PART 5: Development Presentations

Item 5.2

Ref: 19/05195/PRE
Location: 550 to 550A Purley Way, Croydon, CR0 4RF
Ward: Waddon
Description: Demolition of existing commercial properties, erection of two blocks, a southern block of 8 storeys, and northern block up to 15 storeys, providing 125 homes including 4 live/work units, with car and cycle parking and associated landscaping.
Drawing Nos: 6851 DAS, 002 J, 003 F, 005 G, 006 G, 007 G, 008 H, 009 G, 010 G, 013 F, 014 F, 015 F, 016 D, 017 B, 0100, 0102, 0201, 0202, 0203, 0204, 0205, 0206, 0400 B, 0401 B, 0402 A, 0403 A, 0404 A, 0410 A, 0500 A, 0501 A, 0502 A.
Applicant: Stonegate Homes Limited
Agent: Nik Smith, Nexus Planning
Case Officer: Barry Valentine

Fig 9 – Views from Applicant's model looking north and south

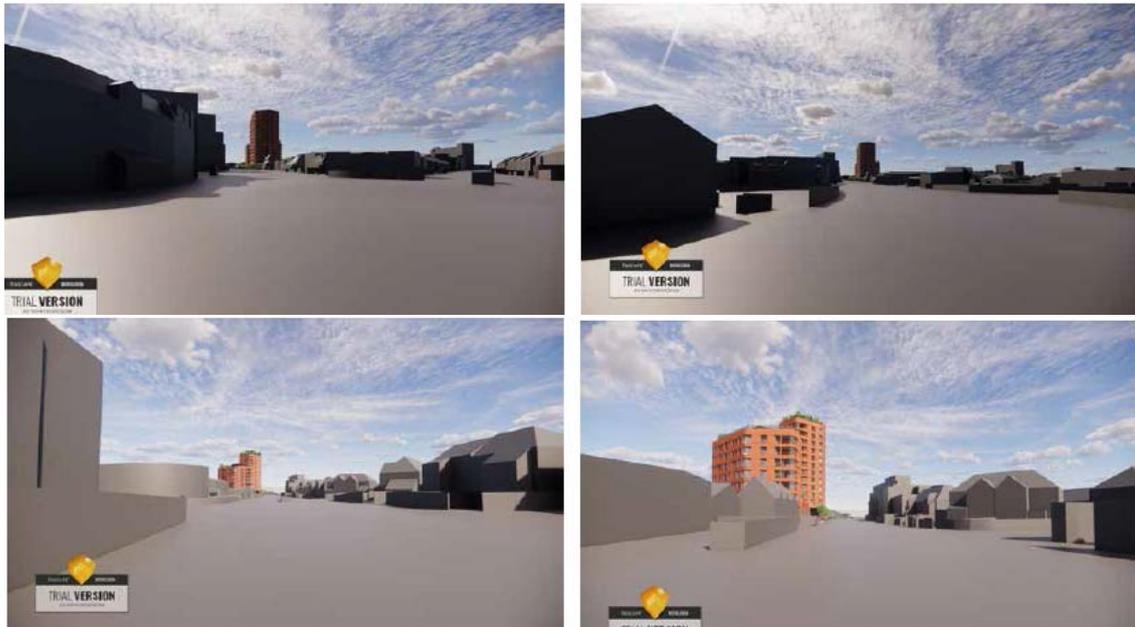
6.33 The proposed tower would form a prominent landmark building, marking the entrance to emerging Five Ways local centre. The building has the potential to add character and visual interest that would be valuable to help create a sense of place, while also informing the future development of Purley Way. A basic model analysis has been provided by the applicant; see extract below. A more detailed and through analysis, including contextual rendering, is advised to be submitted upon application so a full picture of impact on the townscape and long range views can be formed.

Fig 12- Appearance and Material Precedents Provided by Applicant

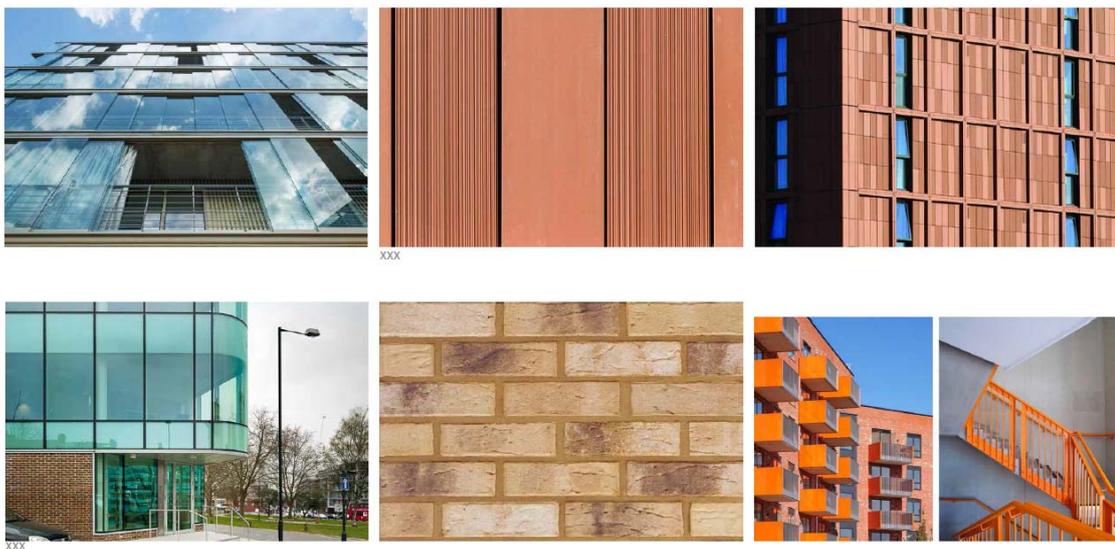
6.41 Officers do have concerns about terracotta, as it is not clear how this relates to or has been informed by the existing context and lacks a clear design narrative. The precedents provided to date are of a questionable design quality and do not appear to have been critically analysed. Many of the examples are taken at close range, and it is not clear whether these work on a grander scale. Terracotta is very varied material and can have rich interesting detailing, however the panels shown on submitted CGIs lack variation in tone, texture or detailing. They could give the building quite a commercial appearance, which would be at odds with the residential nature of the intended use and could potentially exaggerate the massing. It is expected that the applicant will further develop their proposal and the scheme presented to committee be more refined than versions presented to date to officers.

Fig 14 - Showing location of affected window within nos. 453 to 461.

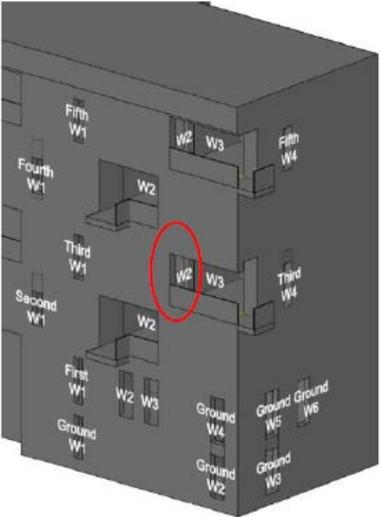
- 6.47 In terms of Vertical Sky Component (VSC) test, there are only three minor failures to surrounding existing residential properties, a window on nos. 453 to 461 Purley Way, and two flank windows located on the side elevation of no.590. The failing window on nos. 453 to 461 is a bedroom window located at third floor level highlighted below. This window would experience a ratio reduction of 0.7, compared to 0.8 target recommended. The bedroom window sits recessed within a balcony, which makes it overly sensitive to change. BRE notes that guidance should be applied more flexibly in such instances. Officers consider that this bedroom would retain good levels of daylight, and that the marginal breach in VSC value to this window is acceptable. The failing windows on no.590 are located on the flank elevation, but both these windows would retain VSC values in excess of 23%, which is considered good, especially given their location on a flank elevation which makes them reliant on light coming over the applicant’s site. There are currently no known sunlight failures to existing residential properties, but there are failures noted in properties that are currently under construction (see paragraphs below).
